# HUGHES SERVICE INFORMATION NOTICE

NOTICE NO. N-147.4\*

SUBJECT: RELOCATION OF STARTING VIBRATOR CIRCUIT WIRING

MODELS AFFECTED: Model 269A (TH-55A) Helicopter Serial No. 0315 and subs  
Model 269B Helicopter Serial No. 0001 and subs  
Model 269C Helicopter Serial No. 0001 thru 1119

Figure 1. Wiring diagram - starter relay/starting vibrator

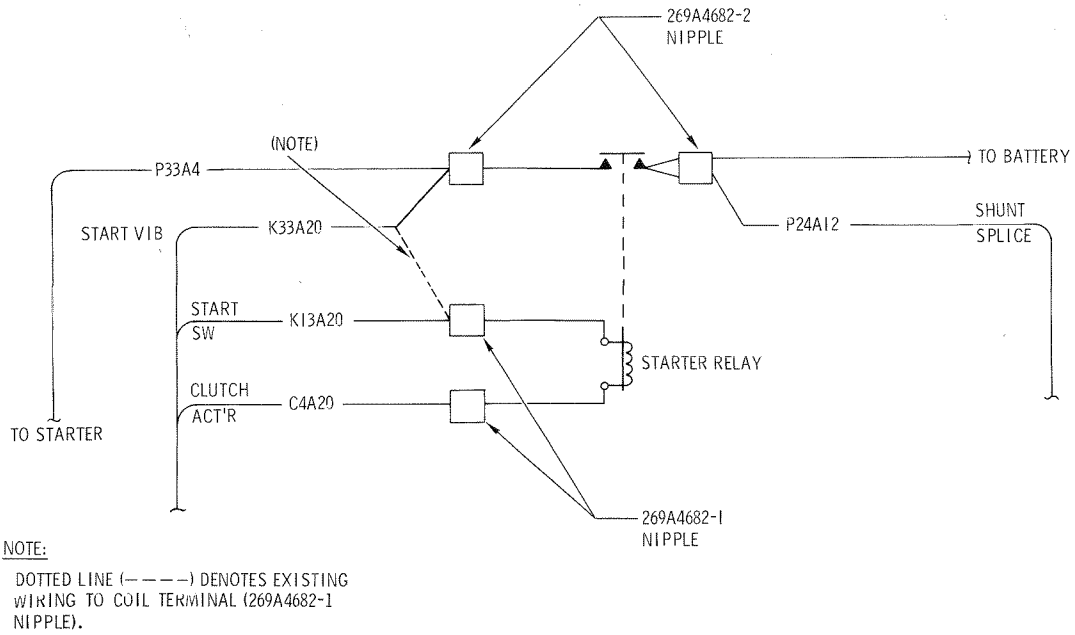
PREFACE: Field reports indicate that, during a ground check of the clutch actuator, engagement of the starter and rotation of the main rotor blade occurred, due to a diode in the actuator circuit shorting out.

- a. Disconnect existing starter vibrator wire lead (K33A20) from coil terminal (269A4682-1 nipple) of starter relay. (See Figure 1.)
- b. Connect wire lead to load terminal (269A4682-2 nipple) of starter relay as shown. Use new MS25036-149 or AMP 31888 terminal lug.
- c. Record compliance with this Service Information Notice in Compliance Record of helicopter Log Book.

Figure 2. Wiring diagram - clutch linear actuator assembly

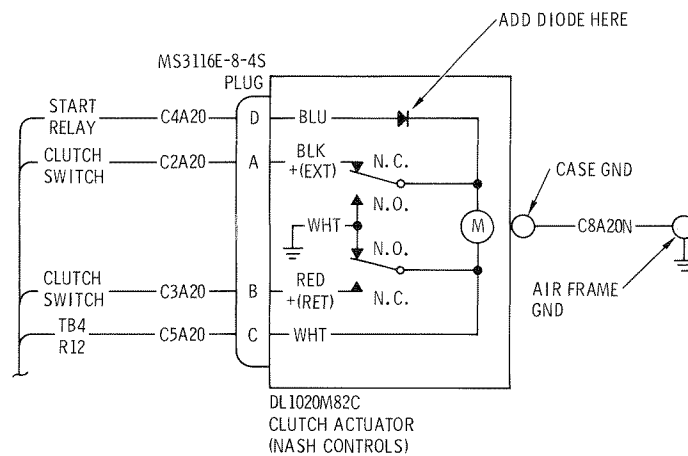
The MR504 or IN4722 diode installed in early type clutch actuator assemblies per Notice No. N-147.3 is to be retained. (see Figure 2.)
